COTTAGE GROVE CITY COUNCIL

- J Glacial Valley Park Building - Change Order #1
Staff Recommendation: Approve Glacial Valley Park change order #1 in the amount of \$42,434.61.
- K Marathon Community Investment Grant Acceptance
Staff Recommendation: Accept and approve the Marathon Community Investment Grant in the amount of \$5,000.00.

GLACIAL VALLEY PARK BUILDING

RCP GENERAL NOTES

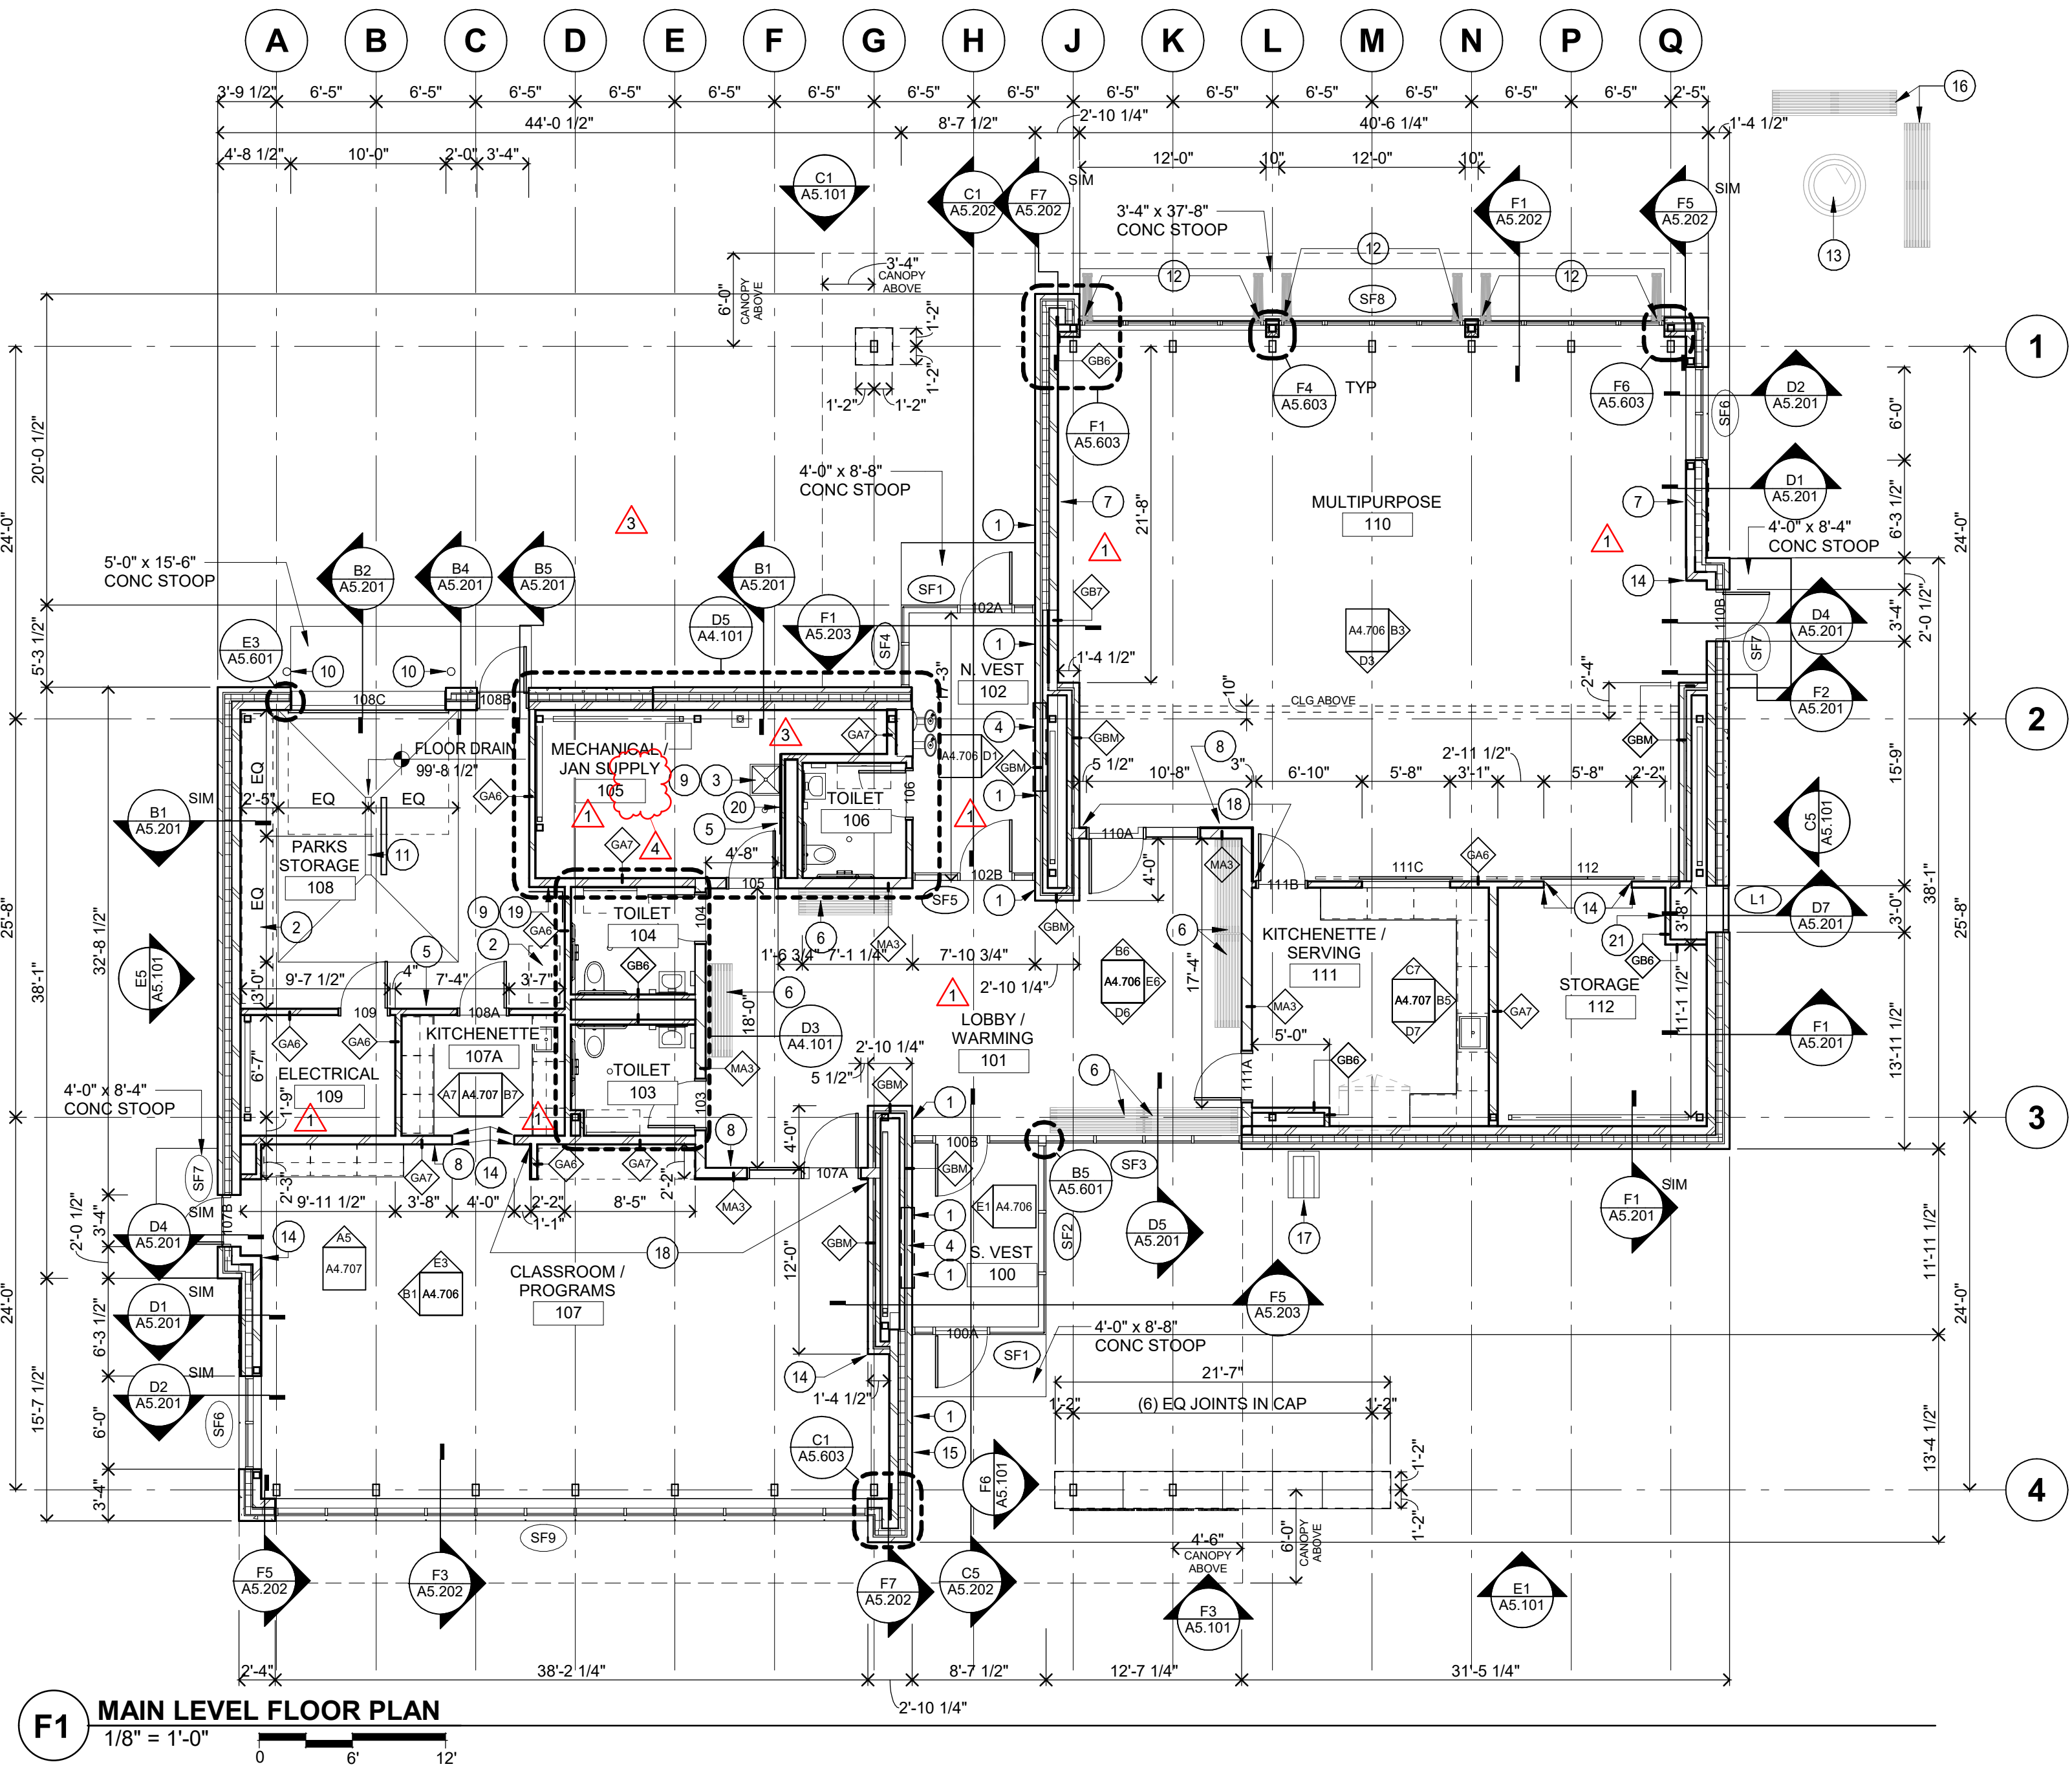
4.8	See sheet E1.00 for revisions to lighting in Toilet 106.
4.9	Refer to sheet A2.001 for revisions to ceiling heights, ceiling transitions, and diffuser locations.

4.10	Refer to sheet A2.001 for lighting reductions and modified access panel in Toilet 106. Added Access panel (AP #3) shall be ceiling mounted 48" x 64" double door with cam latch per the attached drawing from Nystrom or equal.

E4 MECHANICAL ROOF PLAN
1/8" = 1'-0"

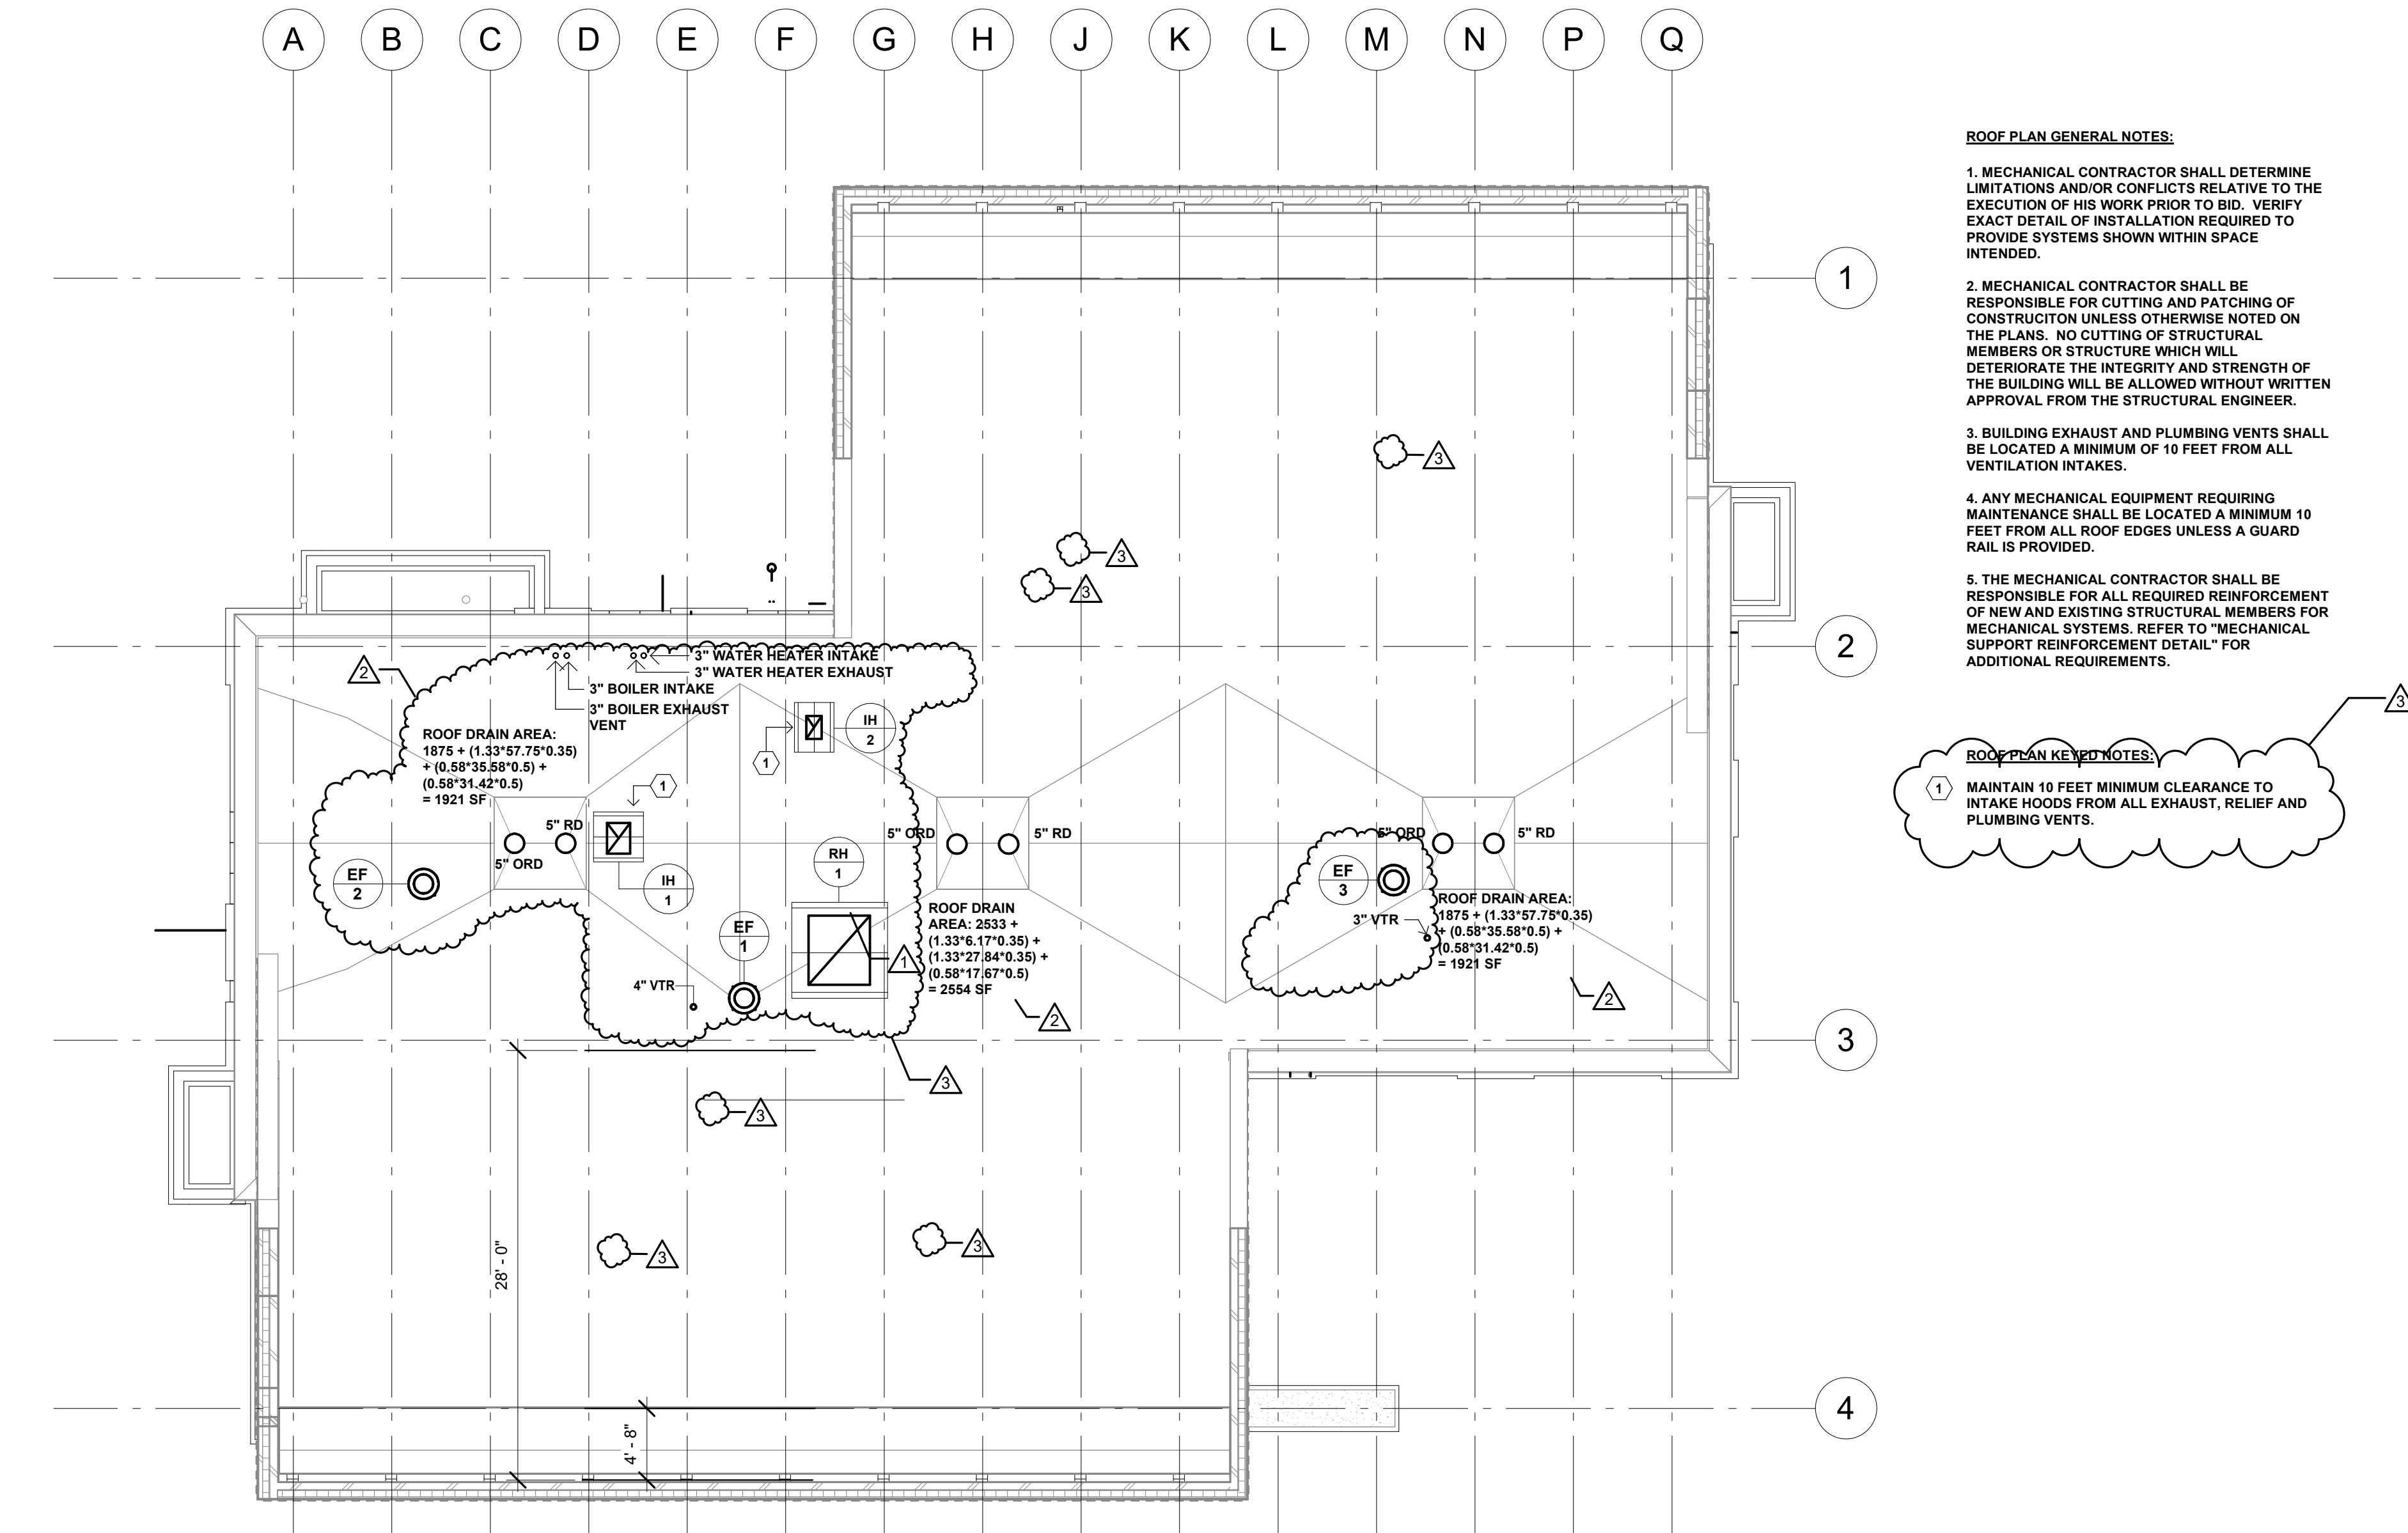
4.4	See revised sheet M4.0 for updated west roof drain locations as per RFI#019. For updated VTR, Exhaust Fan-1, Exhaust Fan-2, Boiler Intake and Exhaust Vent, Water Heater Intake and Exhaust Vent, and Relief Hood location. For the addition of Intake Hood and their locations. And for removing the thermostats from the roof.

F4 POWER & SYSTEMS PLAN 1/8" = 1'-0"

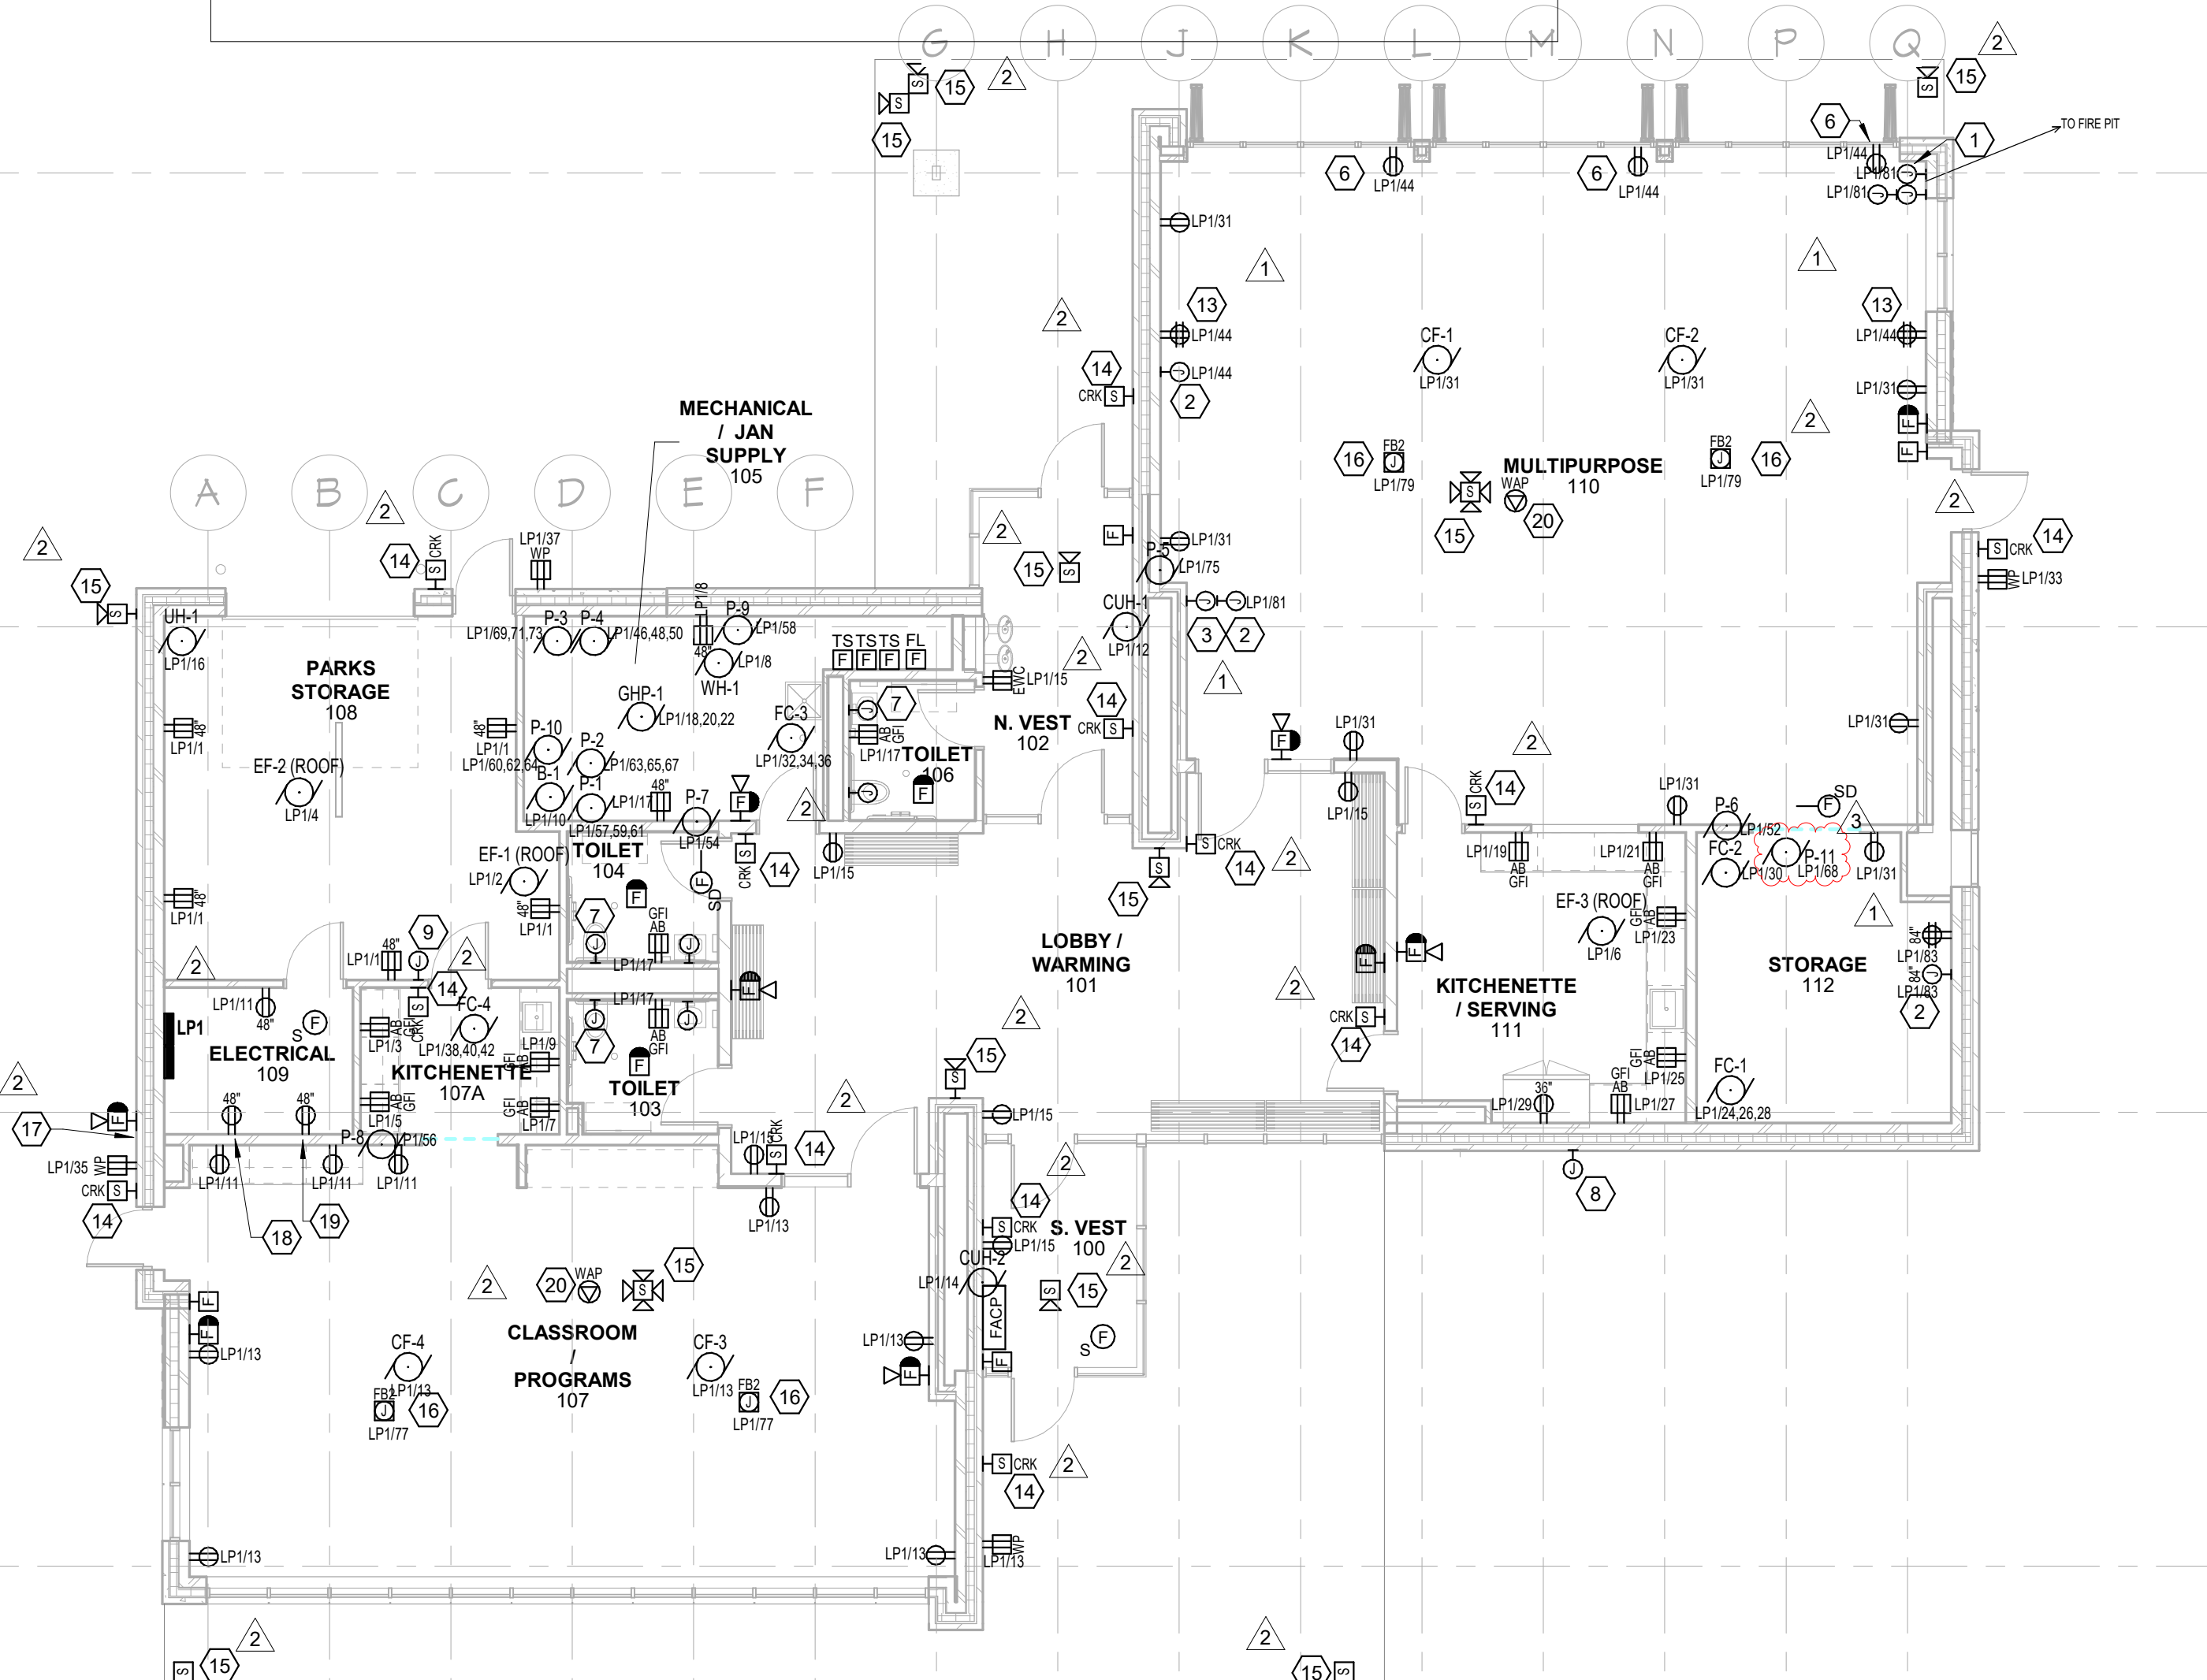
Item	Description
	For updated Intake and Relief Hood Schedule.
4.7	See revised sheet E1.00 for the addition of the Condensate Pump (P-11) and its location.
